Historical Affairs and Landmark Review Board

HALRB Meeting June 18, 2025, CoA 25-01A

3209 23rd St. N.: Amendment to CoA 25-01 for new location of shed.

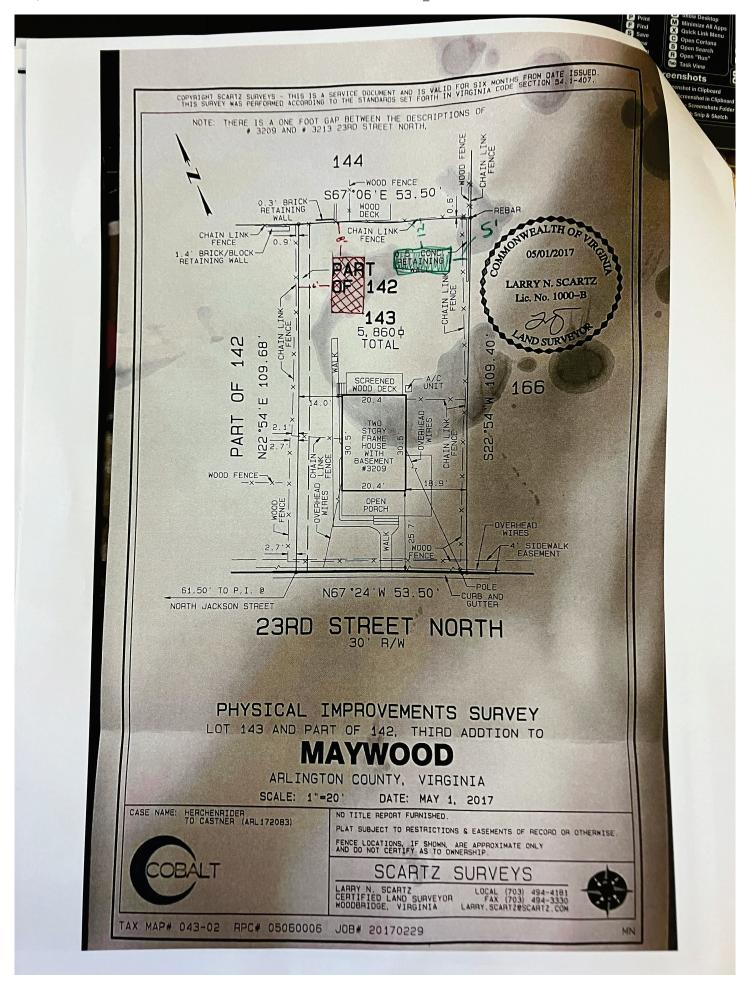
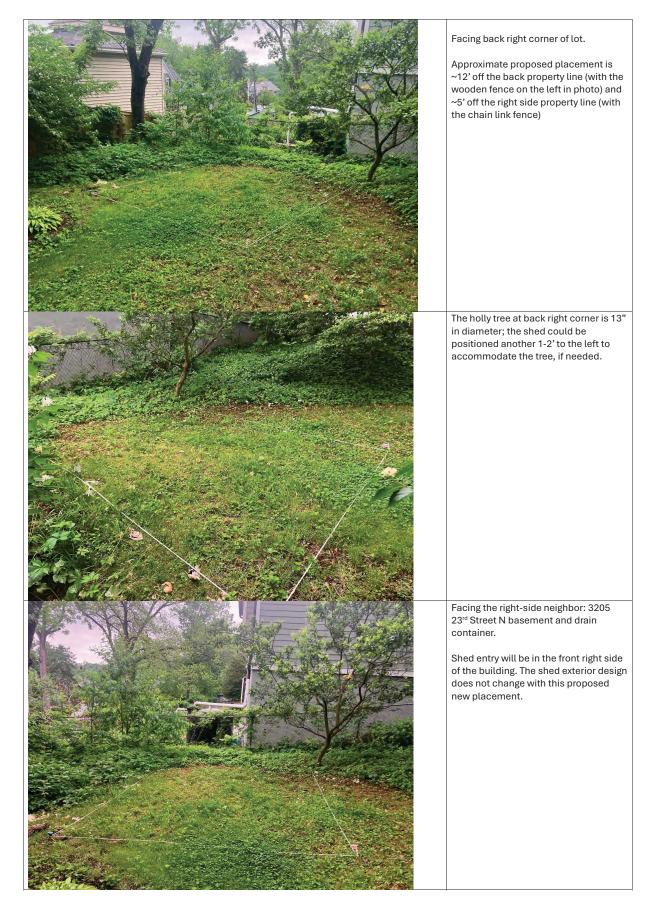
Applicant will use chicken wire and wood lattice in between the posts at the foundation of the shed.
